Kirkland NE 85th St Station Area Plan and Planned Action

Final Supplemental Environmental Impact Statement
December 2021

Subject: Final Supplemental Environmental Impact Statement (FSEIS) for the Kirkland NE 85th St Station Area Plan, Form-Based Code, and Planned Action

Revised Exhibit 3-67 (page 3-141). Transportation Network Assumptions, Alternative 3

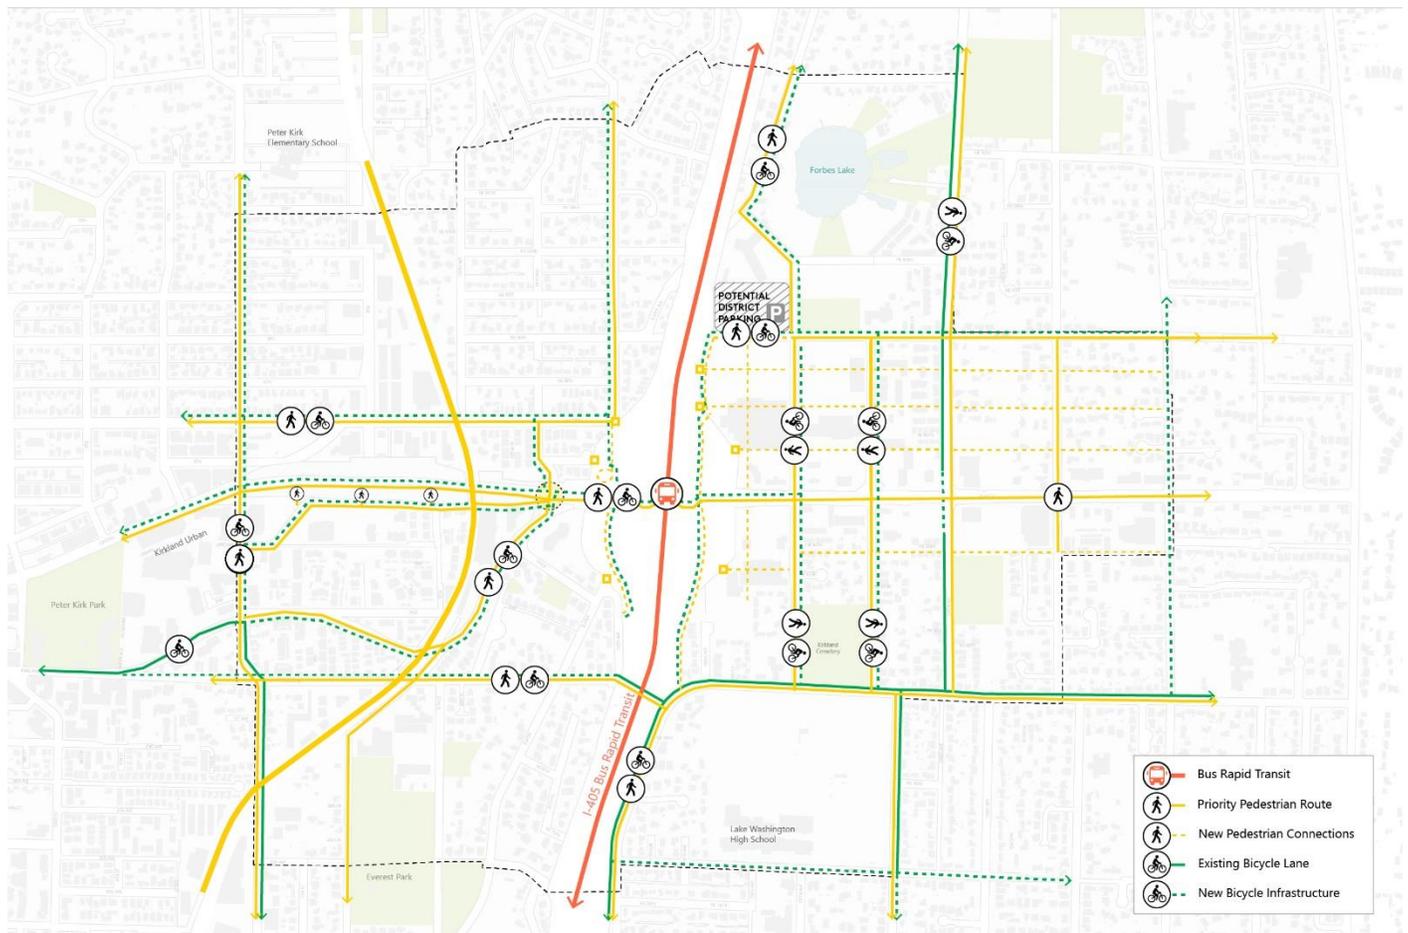
Number	Commenter and Summary	Response
106-4	Exhibit 3-67 shows east-west bike routes with grades too high to be useable. Adding bike lanes to both sides of NE 85 th St would be preferable.	The comments are noted and forwarded to City decision makers. See FSEIS Alternative B transportation investments in non-motorized facilities in FSEIS Section 3.6.
106-5	An error on page 3-154: in the Pedestrian and Bicycle paragraph the reference to Exhibit 3-76 should be to 3-66.	Comment noted. See Chapter 4 for errata.
107	Susan Vossler	
107-1	Reduce emissions by requiring that all new construction be 100% electric and net zero energy.	The comments are noted and forwarded to City decision makers. It is anticipated the Form-Based Code would include sustainability incentives. See FSEIS Alternative B description in Chapter 2.
108	Dan & Cass Walker	
108-1	Prefer Alt 1 and height limits of six stories.	The comments are noted and forwarded to City decision makers.
